City of Santa Cruz

**DOWNTOWN
~~RECOVERY~~ PLAN**

As Amended through _____ 2017

This redlined version illustrates changes made since the September 2016 version. Chapters 5-7 and the appendices are not included in this version because there were no changes from September 2016.

Figure A-1: Downtown Plan Height

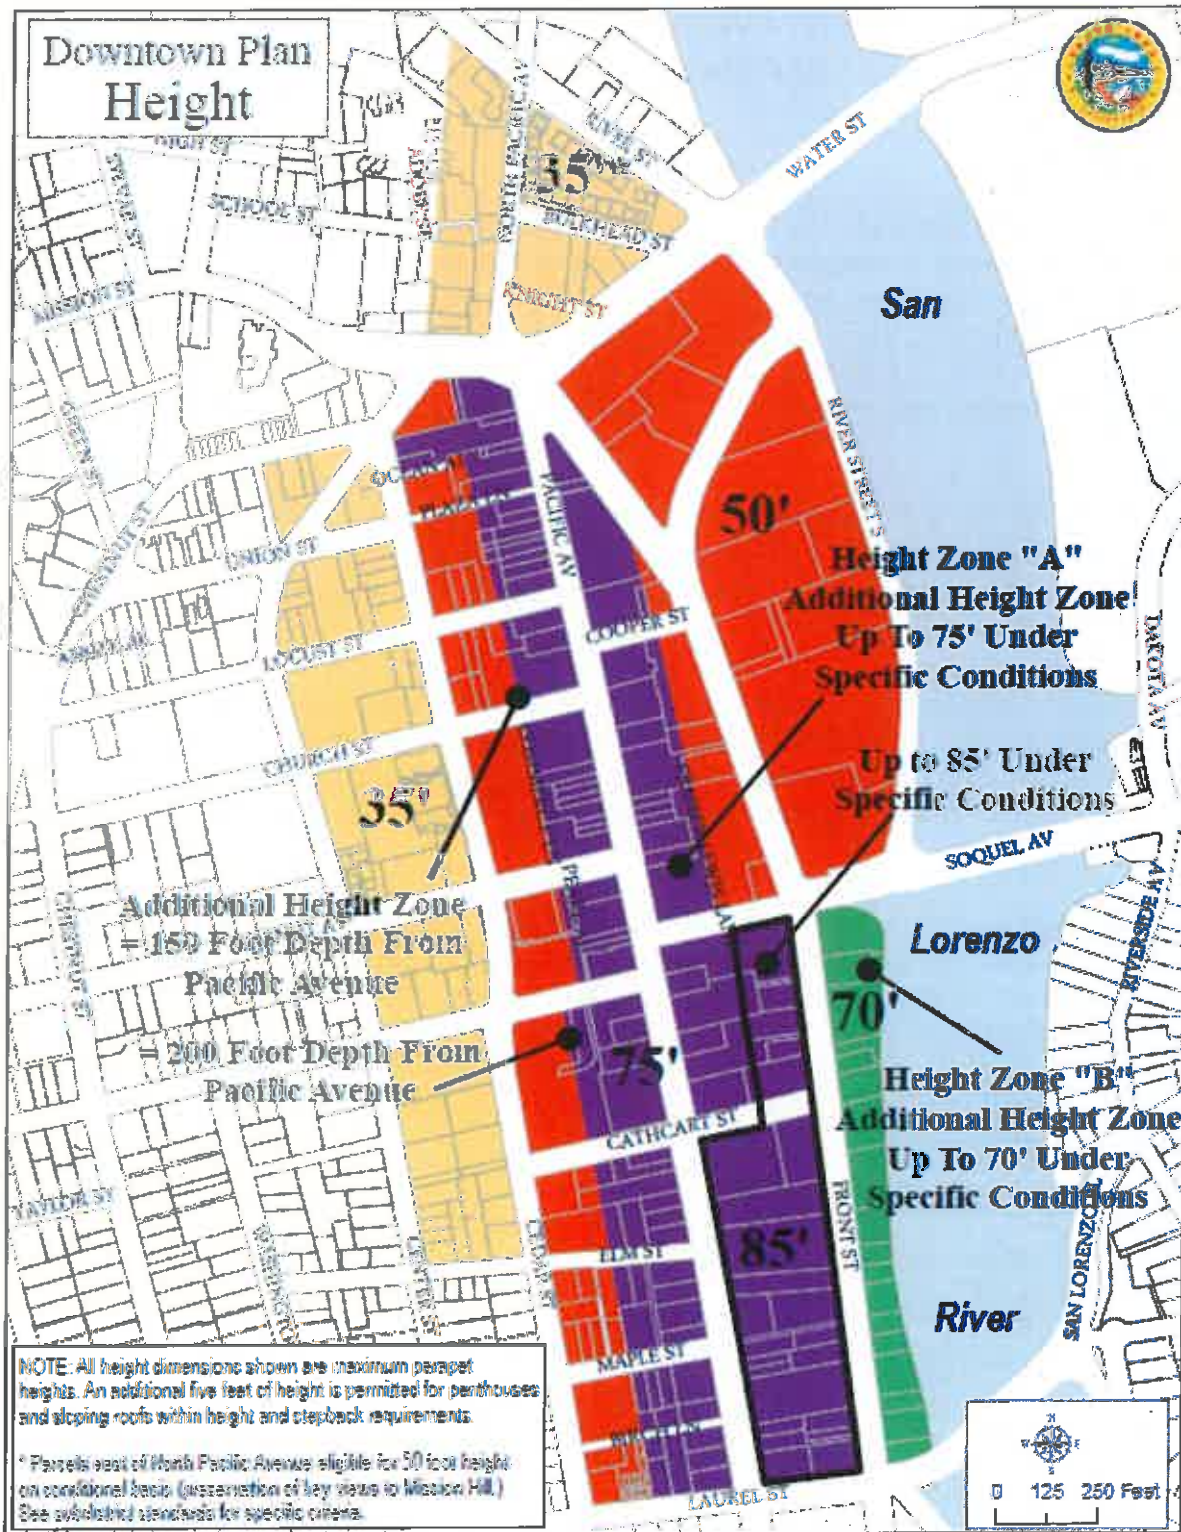
On XXXX, 2017 the City Council adopted revisions to the plan with specific emphasis on Chapter 4, Development Standards and Design Guidelines as Ordinance XXXXX, extending Additional Height Zone A to Laurel Street and modifying Additional Height Zone B for Front Street riverfront properties.

Figure H-1: Proposed distribution percentage of additional height for sites 15,000–50,000 sq. ft.

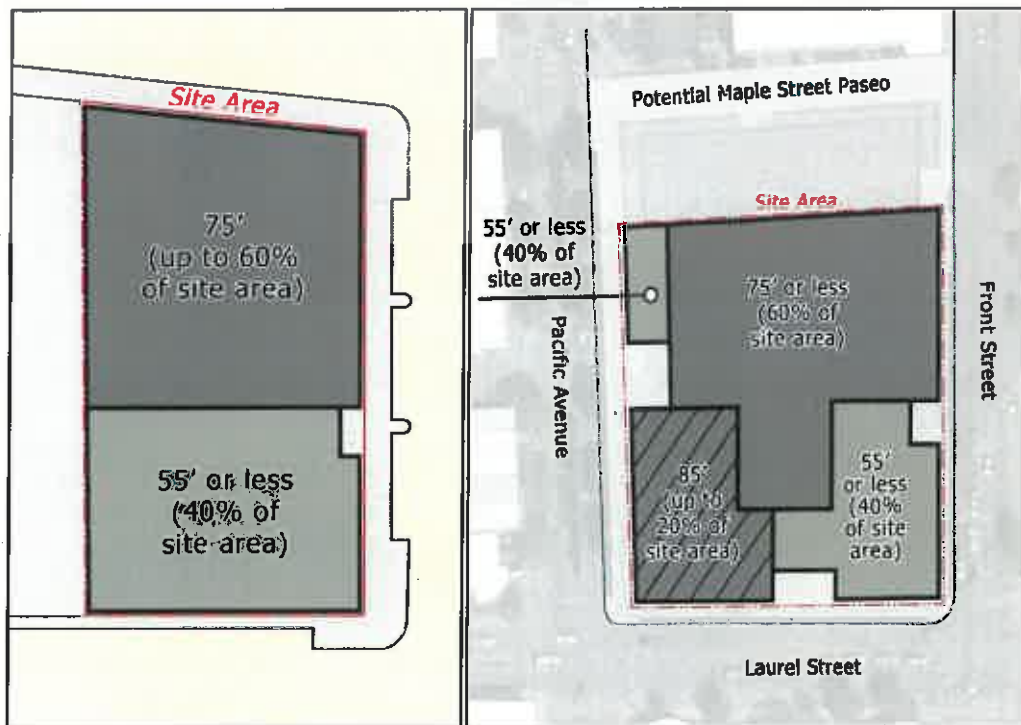
- i. Maximum Height and Footprints. For sites which are eligible for additional height, the footprint of portions of the building at or below 55 feet shall be at least 40% of the total site area; portions of the building footprint above 55 feet to a height of 75 feet may comprise up to 60% of the site area. For assembled sites greater than 50,000 square feet in area, buildings may achieve an 85-foot height for up to 20% of the total site area. (See Figure H-1)

Figure H-2: Example of possible distribution of frontage heights along Pacific Avenue and Laurel Street.

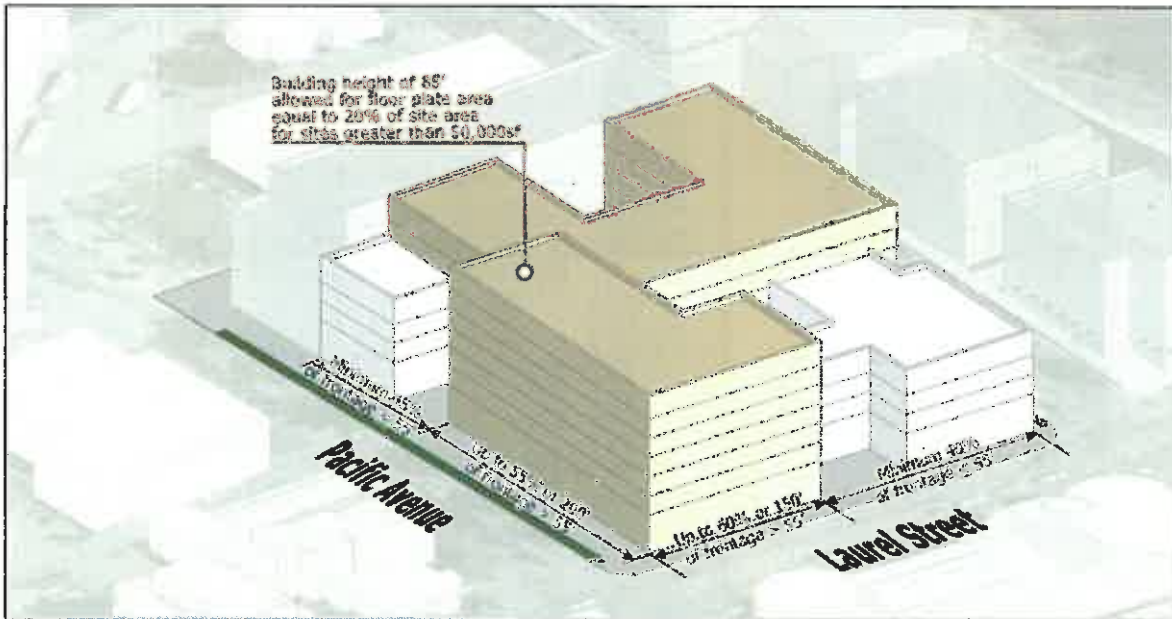
- iii. **Pacific Avenue Building Length.** Along Pacific Avenue, portions of buildings that exceed the maximum base height of 55 feet may occupy up to 55% of the length of the property line along the street or 200 feet, whichever is less. Any additional height above the base height must be set back from the building wall by at least 15 feet. (See Figures H-2 and H-4)

feet, whichever is less. Any additional height above the base height must be set back from the building wall by at least 15 feet. (See Figure H-2)

Figure H-3: Example of possible distribution of frontage heights along Front Street and the Maple Street Paseo.

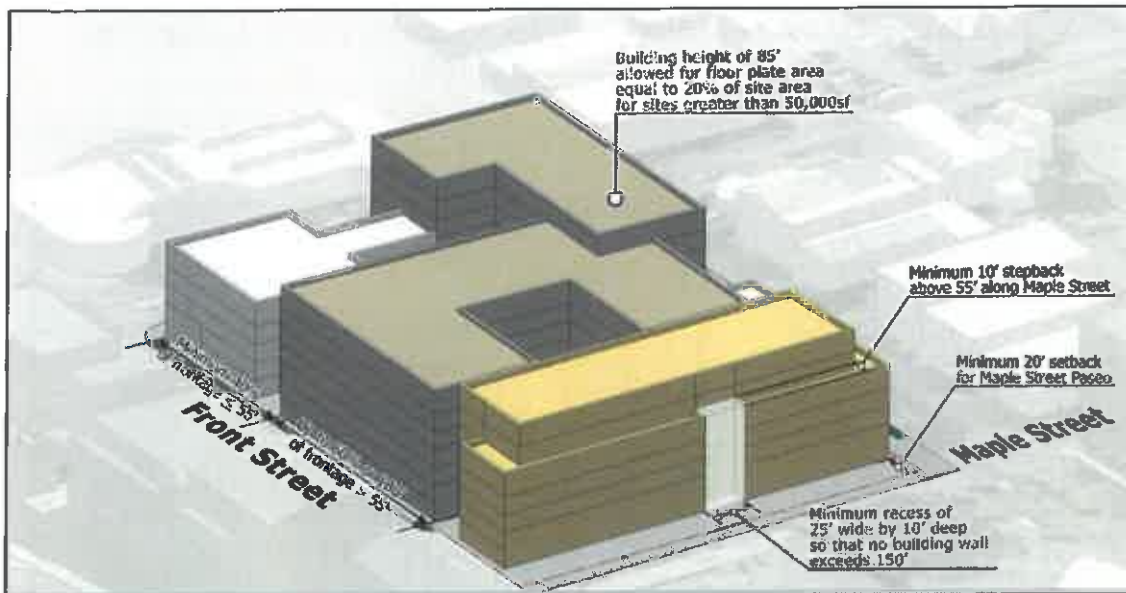
- iv. **Front Street Building Length.** Along Front Street, portions of buildings that exceed the maximum base height of 55 feet may occupy up to 60% of the length of the property line along the street or 180 feet, whichever is less. Any additional height above the base height must be set back from the building wall by at least 15 feet. (See Figure H-3)

- vi. **Maple Street Stepbacks.** Along the Maple Street extension, the building frontage shall step back by 10 feet above a height of 50 feet; In addition to the 'build to' line The Maple Street building face shall incorporate at least one recessed break, open to the sky, no less than 25 feet wide and no less than 10 feet in depth from Maple Street . (See Figure H-3)

Figure H-7: Example of distribution of frontage heights and horizontal massing variation along Front Street.

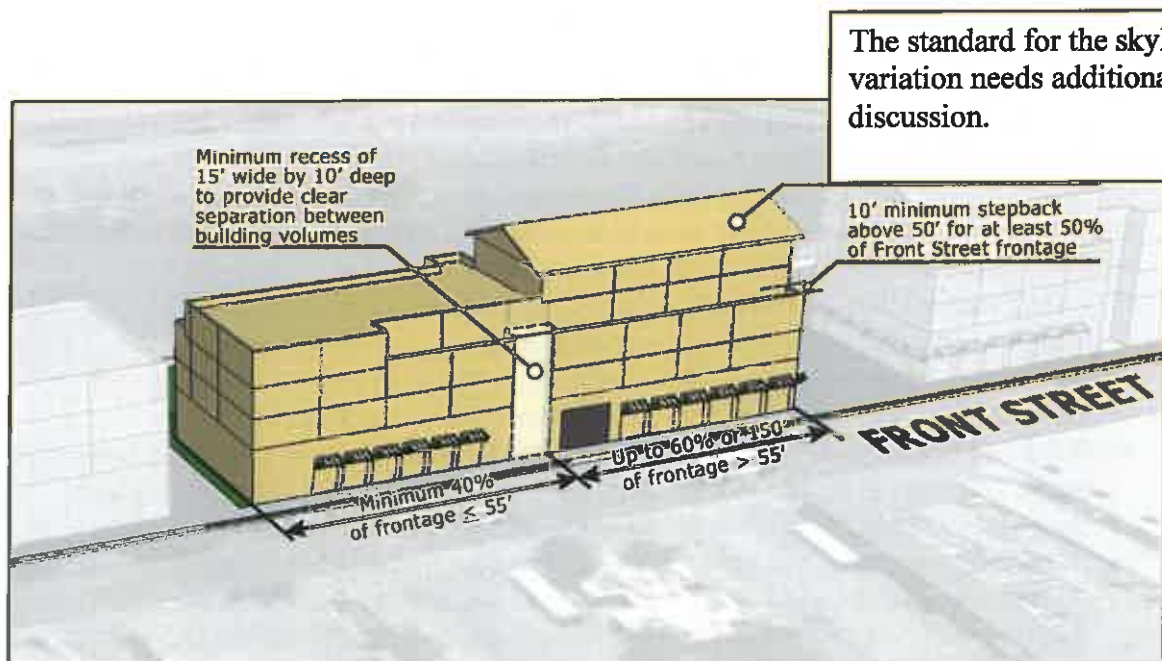
- i. Building Recessed Breaks. In order to break down the mass of buildings along Front Street and to promote the appearance of multiple buildings, require any portion of the building mass that exceeds the maximum base height of 50 feet to establish a separation or break that is open to the sky, measuring at least 15 feet along the streetfront property line, with a depth no less than 10 feet as measured perpendicular from the streetfront property line. (See Figures [H-7](#), [H-5](#), and the [photos below Figure H-5H-5 and H-7](#))
